**Re: 1010 Pipe and Casing  
5609 Alameda Pl. NE  
Traffic Circulation Layout  
Architect's Stamp 05-22-22 (C18-D015)**

Based upon the information provided in your submittal received 07-18-22, the above referenced plan cannot be approved for Building Permit until the following comments are addressed:

May 2022		SHEET NO.
© 2022 McElheney Architects, P.C.		
	1010 Pipe and Casing	AS1
	ALAMEDA /PL NE. Albuquerque, NM 87112

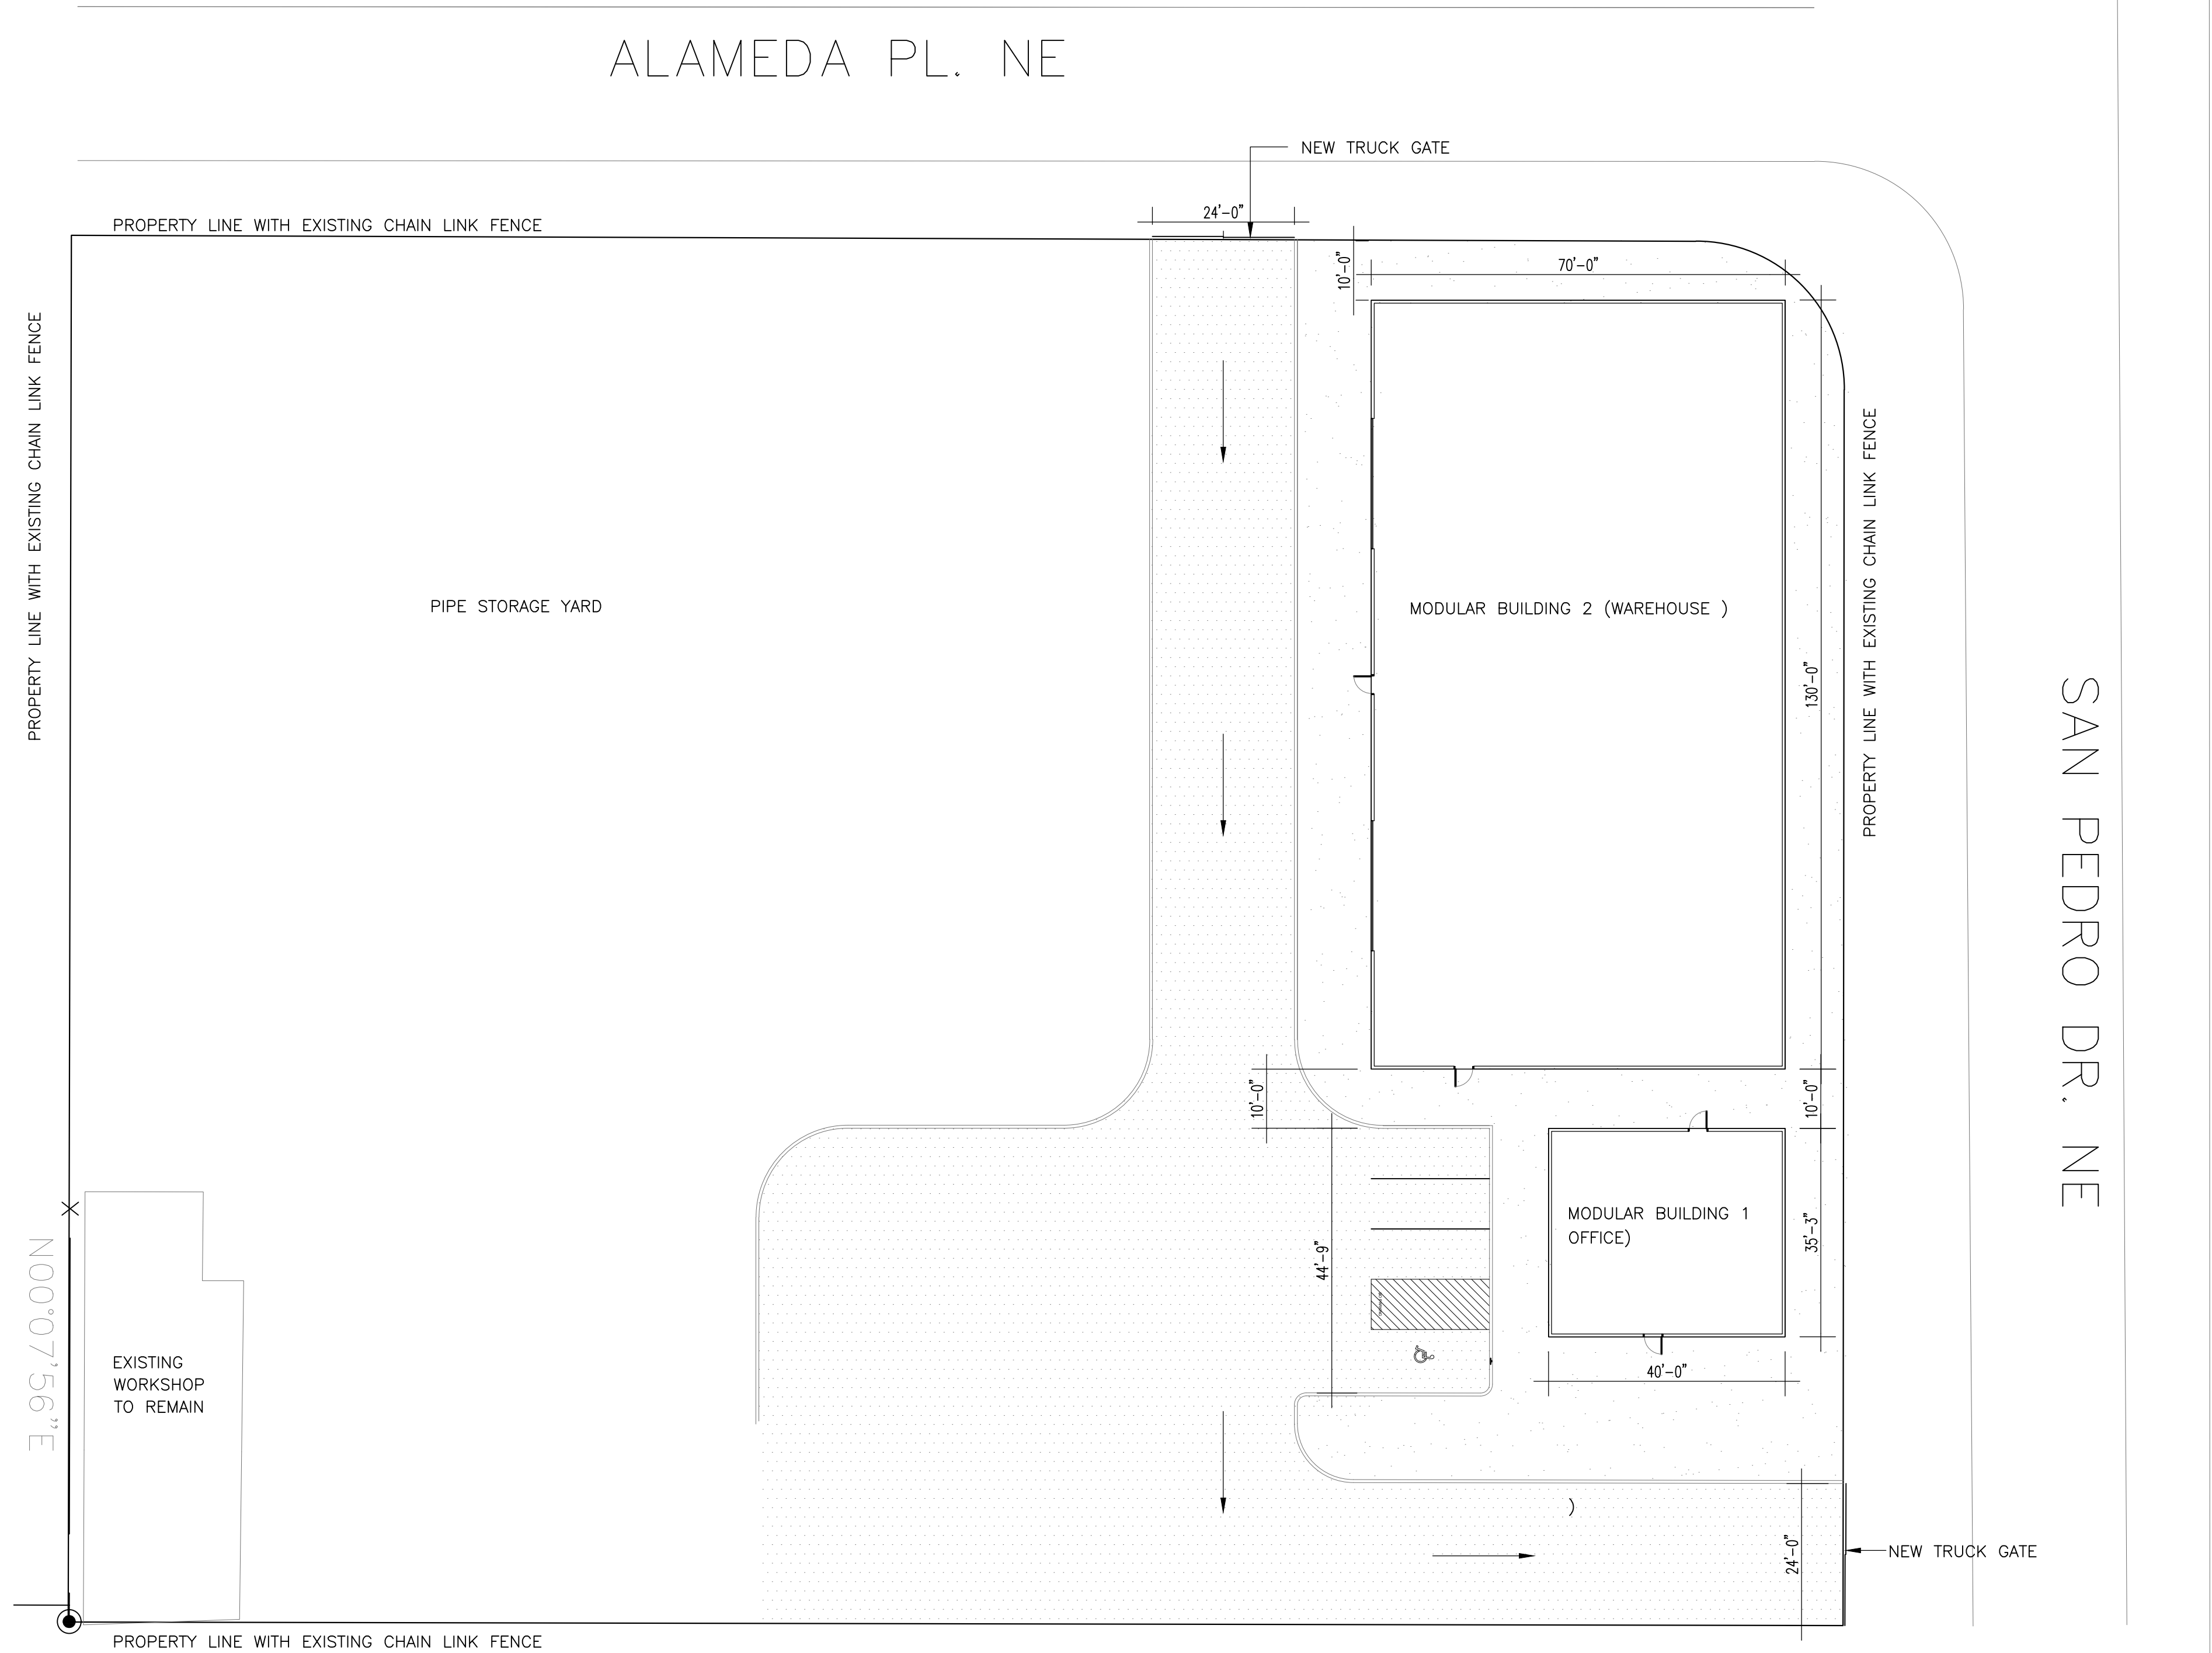
1. Please show a vicinity map showing the location of the development in relation to streets and well known landmarks.
2. Please show on site plan the North arrow.
3. List the number of parking spaces required by the IDO as well as the proposed number of parking spaces including bicycle and motorcycle parking.
4. Identify the right of way width, medians, curb cuts, and street widths on San Pedro Dr. and Alameda Pl NE.
5. Alameda frontage and San Pedro frontage: Sidewalk need to be built per COA std dwg 2430 and Curb and Gutter per COA std 2415 from property line to property line. For sidewalk waiver please contact Ernest Armijo [earmijo@cabq.gov](mailto:earmijo@cabq.gov). (505)-924-3991
6. Please list the width and length for all existing and proposed parking spaces. Some dimensions are not shown.
7. The minimum parking stall dimensions are:

8. The ADA accessible parking sign must have the required language per 66-7-352.4C NMSA 1978 **"Violators Are Subject to a Fine and/or Towing."** Please call out detail and location of signs.
9. Motorcycle parking spaces shall be designated by its own conspicuously posted upright sign, either free-standing or wall mounted per the zoning code.

10. All bicycle racks shall be designed according to the following guidelines:
  - a. The rack shall be a minimum 30 inches tall and 18 inches wide.
  - b. The bicycle frame shall be supported horizontally at two or more places. Comb/toaster racks are not allowed.

- c. The rack shall be designed to support the bicycle in an upright position. See the IDO for additional information.
  - d. The rack allows varying bicycle frame sizes and styles to be attached.

- e. The user is not required to lift the bicycle onto the bicycle rack.
  - f. Each bicycle parking space is accessible without moving another bicycle.

11. Bicycle racks shall be sturdy and anchored to a concrete pad.
12. A 1-foot clear zone around the bicycle parking stall shall be provided.
13. Bicycle parking spaces shall be at least 6 feet long and 2 feet wide.

14. List radii for all curves shown; for passenger vehicles. Radius for delivery trucks, fire trucks, etc. is 25 ft. or larger.
15. Per the IDO, a 6 ft. wide ADA accessible pedestrian pathway is required from the public sidewalk to the building entrances. Please clearly show this pathway and provide details.

16. Per DPM, a 6 ft. wide ADA accessible pedestrian pathway is required from the ADA parking stall access aisles to the building entrances. Please clearly show this pathway and provide details.

17. ADA accessible pedestrian pathway should not be placed behind parking space or adjacent to a vehicular way. Vehicle and pedestrian/wheel chair conflicts should be avoided as much as possible.

18. Refuse vehicle maneuvering shall be contained on-site. The refuse vehicle shall not back into the public right of way. provide a copy of refuse approval.

19. Provide a copy of Fire Marshal approval.
20. It is not apparent what type of pavement surface is being proposed. A hard driving surface will be required as part of this proposed project for parking area and drive aisles.

21. All one-way drives shall have "One Way" and "Do Not Enter" signage and pavement markings. Please show detail and location of posted signs and striping.

22. Please provide all proposed face signs details.
23. Please provide a sight distance exhibit
24. Show the clear sight triangle and add the following note to the plan: "Landscaping and signage will not interfere with clear sight requirements. Therefore, signs, walls, trees, and shrubbery between 3 and 8 feet tall (as measured from the gutter pan) will not be acceptable in the clear sight triangle.

25. Please specify the City Standard Drawing Number when applicable.

26. Provide notes showing what work is included and on the work order and the private work on site.
27. Work within the public right of way requires a work order with DRC approved plans.
28. Please add a note on the plan stating "All improvements located in the Right of Way must be included on the work order."
29. Please provide a letter of response for all comments given.

Type of parking	Min. Width	Min. Length	Min. Overhang
Standard	8.5'	18'	2'
Compact	7.5'	15'	1.5'
Motorcycle	4'	8'	N/A
ADA	8.5'	18'	2'
